SERVICE BULLETIN 14-03-33

MODELS CONCERNED: MK4 300 Litre Powered Grass Collector

CONCERN: Current PGC is supplied with a drive belt suitable for MK4

PGC Drive Belts

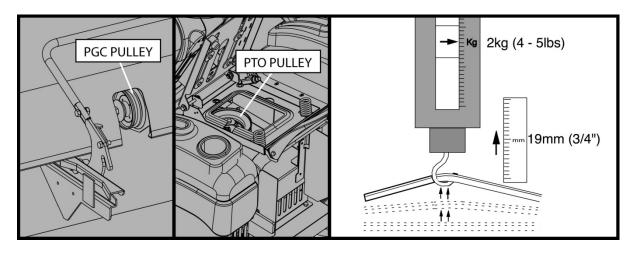
tractors only.

The new 2014 MK4 PGC is supplied with an A51 drive belt. The belt links the tractor PTO to the PGC input pulley. This belt is incompatible with earlier tractor models. Existing pre MK4 tractors will require an A49 belt in order to function as designed. The A49 belt is not supplied as standard and should be purchased as an addition at order stage.

Both A51 & A49 belts should be tensioned to 19 mm deflection at 2kg pull force.
